**UPDATED 7-8-15 DRAFT Proposed Changes
Public Review Draft Emerson East-Eken Park-Yahara Neighborhood Plan**

The Emerson East-Eken Park-Yahara (EEEPY) Neighborhood Plan Steering Committee hosted a Public Open House on June 9, 2015 to present the Public Review Draft EEPY Neighborhood Plan for review and comment. The comment period was open through June 30th and all public comments received through that date were provided to the Steering Committee. In addition, city staff reviewed the Public Review Draft Plan and provided comments.

Based on all comments, Planning Division staff recommends the following changes to the Public Review Draft Neighborhood Plan. The EEPY SC will be tasked on July 8 at its SC meeting with deciding on any changes the group would like included in the Final Draft EEPY Neighborhood Plan based on this memo and all comments received to date.

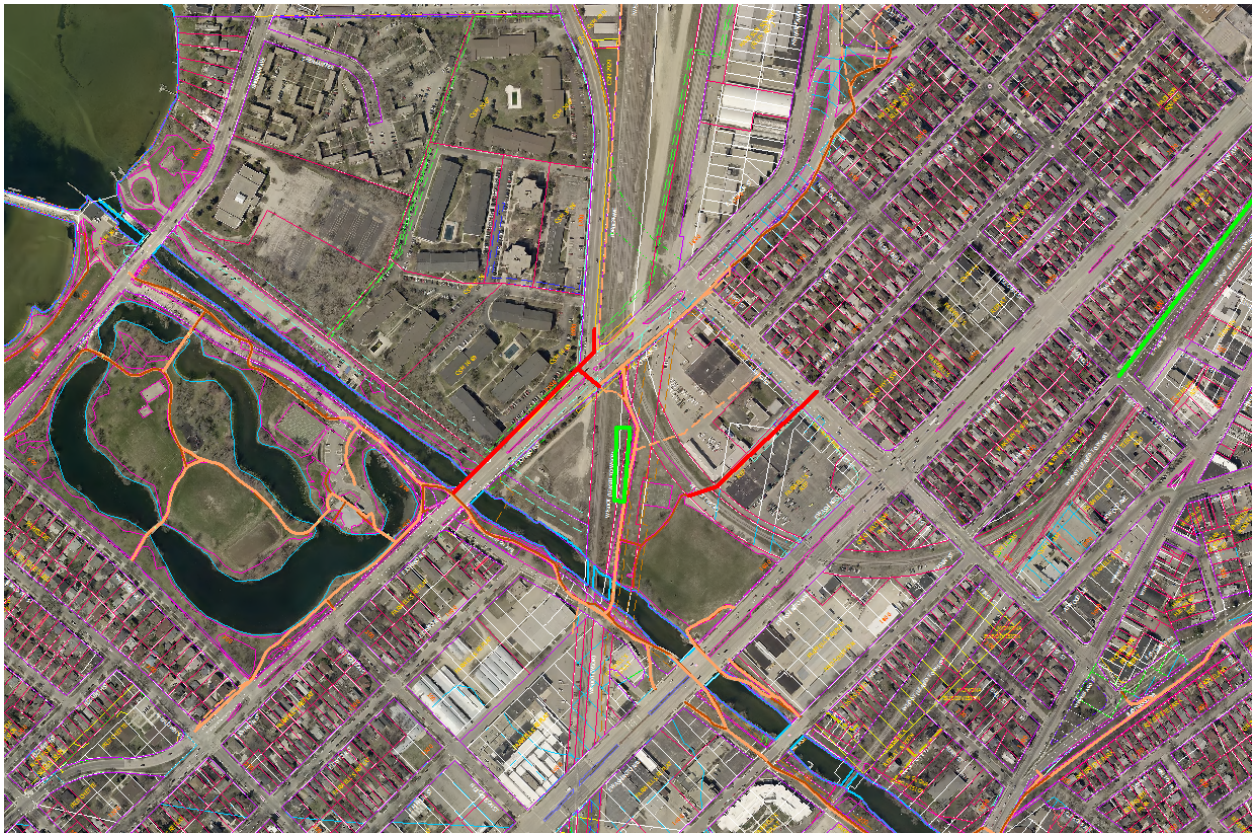
- Add ped/bike path and/or sidewalk recommendations as shown in attached emails between Planning Division and Engineering staff. Refine wording and timeframes with Engineering staff as needed.
- Recommendation #1, bullet #4, add the following text:
 - Develop ped/bike connections from Public Market District to Burr Jones Park, the Yahara River, and surrounding residential areas. **Some specific locations include:**
 - **The block along E. Johnson St., from the west side of the Yahara River, to Fordem Ave.** (Engineering comment - There are very limited bike routes to the North Side, and Fordem is a key one. Getting from there to the Tenney park path is a problem, especially for EB bikes).
 - **From Burr Jones Park to E. Mifflin St., at First St.** (Engineering comment - This small but challenging link would make the Mifflin corridor a major bike corridor).

See Engineering map below for clarification:
